Section 1.0	Introduction	2
Section 2.0	Draft EIR Public Review Summary	3
Section 3.0	Draft EIR Recipients.....	4
Section 4.0	Responses to Draft EIR Comments	6
Section 5.0	Draft EIR Text Revisions.....	58

This document, together with the Draft Environmental Impact Report (Draft EIR), constitutes the Final Environmental Impact Report (Final EIR) for the Morgan Hill Devco Residential Project.

The Santa Clara Valley Water District (Valley Water) provided substantial comments on the Draft EIR, which are presented below under Comment Letter C. Many of these comments were highly technical involving modeling assumptions and methodologies used in the Drainage Report that was included as Appendix H of the Draft EIR, prepared by the consulting civil engineering firm Schaaf & Wheeler, Inc. (S&W). The detailed comments by Valley Water required similarly detailed, technical responses, which were prepared in consultation with S&W, and are attached as Appendix E to this Final EIR. Since many of the comments within the Valley Water letter raised the same concerns and questions, more general master responses that would be useful to the decision-makers and general public have been prepared in order

Comment C.46: Appendix H – Schaaf and Wheeler Flooding and Drainage Study Memorandum, Impact 6 (Page 9)

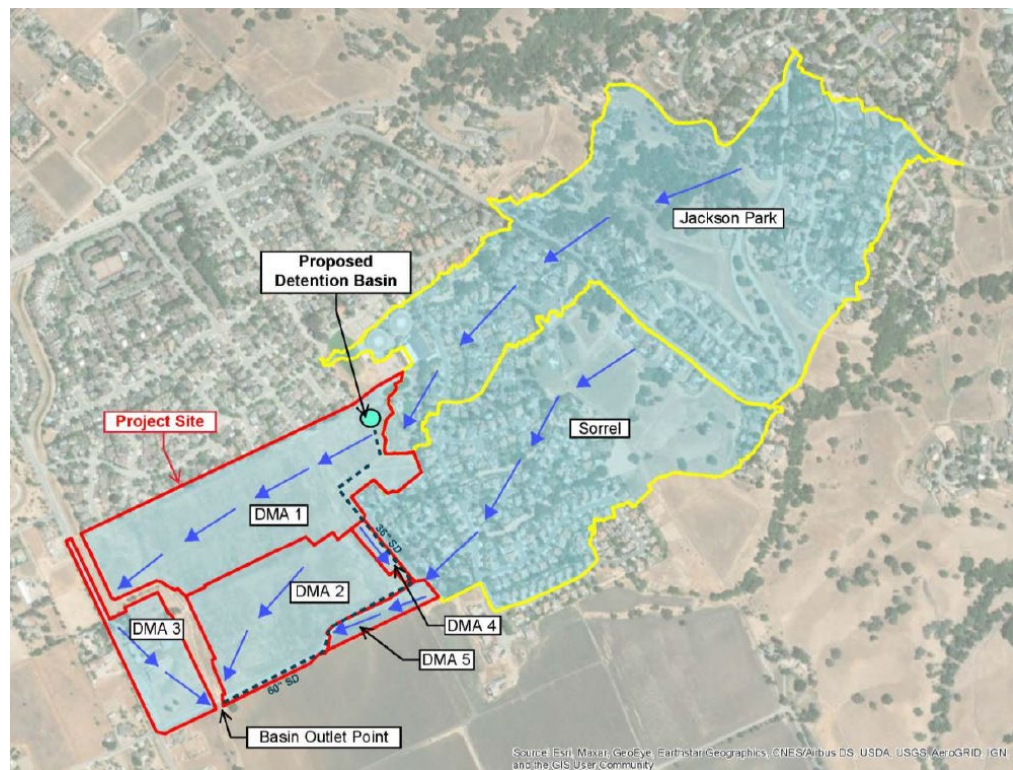
It is noted *"...the detention basin has been designed to the 25-year storm event,"* and based on the modeling results for the 100-year storm event in Tennant Creek *"the development will be out of the floodplain."* See Comments 20a, and 20c. This finding does not acknowledge that Tennant Creek

does not have sufficient capacity for frequent flood events and any increased runoff during these frequent events, which will increase the extent and frequency of flooding downstream. Receiving streams further downstream only have an approximate capacity for the 10-year event. The text supporting a finding of 'Less Than Significant' is inadequate.

Comment C.47: Additionally, Figure 6 provided on this page is illegible, and the outlet or discharge point for all DMAs is not clear. A full sized, legible copy of the figure, along with a clearly marked discharge point needs to be provided.

Response C.47: The revised drainage report (Appendix C) includes Figure 2-2 which shows the post-project conditions drainage areas, including clearly marked discharge points for the DMAs. A snip of the figure is included below.

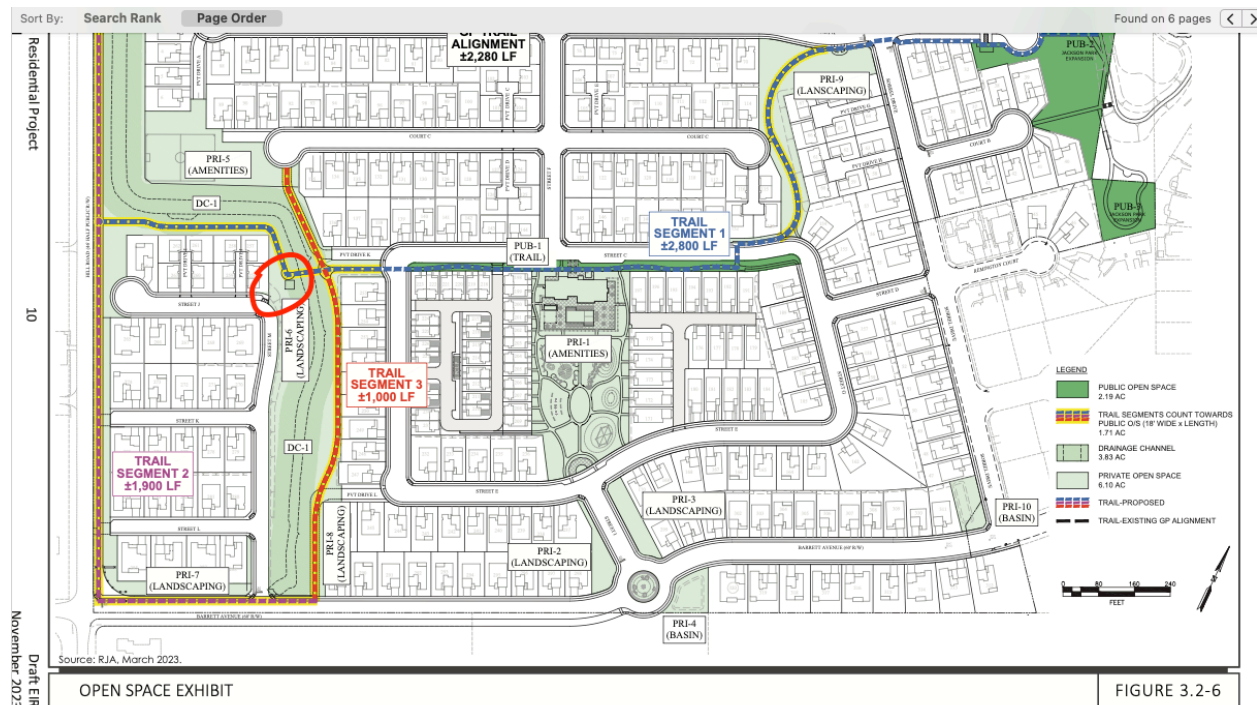
VTa noticed a possible gap in the pedestrian/trail network in the site plan. Overall, the project does a nice job of providing pedestrian/trail connections throughout the site and to neighboring land uses, but there is a gap circled in the screenshot of Figure 3.2-6 below, which seems to require people to walk far out of their way to get to the clubhouse/common areas or over to the elementary school. VTA recommends the project expand the proposed trail network to provide access between Streets J/M and Street C.

Response B.1: The comment pertains to the design of the project's pedestrian/trail network. The City will take this recommendation into consideration during the Design Permit Process. The comment does not question the adequacy of the Draft EIR analysis; therefore, no further response is required.

Comment C.46: Appendix H – Schaaf and Wheeler Flooding and Drainage Study Memorandum, Impact 6 (Page 9)

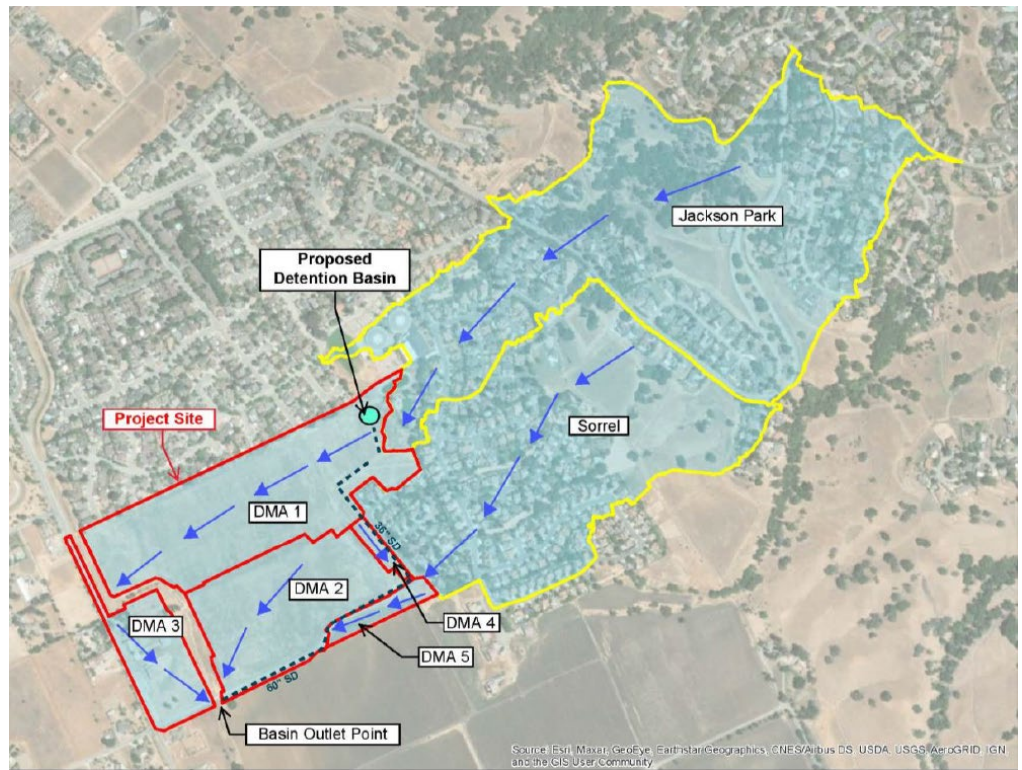
It is noted “...the detention basin has been designed to the 25-year storm event,” and based on the modeling results for the 100-year storm event in Tennant Creek “the development will be out of the floodplain.” See Comments 20a, and 20c. This finding does not acknowledge that Tennant Creek does not have sufficient capacity for frequent flood events and any increased runoff during these frequent events, which will increase the extent and frequency of flooding downstream. Receiving streams further downstream only have an approximate capacity for the 10-year event. The text supporting a finding of ‘Less Than Significant’ is inadequate.

Comment C.47: Additionally, Figure 6 provided on this page is illegible, and the outlet or discharge point for all DMAs is not clear. A full sized, legible copy of the figure, along with a clearly marked discharge point needs to be provided.

Response C.47: The revised drainage report (Appendix C) includes Figure 2-2 which shows the post-project conditions drainage areas, including clearly marked discharge points for the DMAs. A snip of the figure is included below.
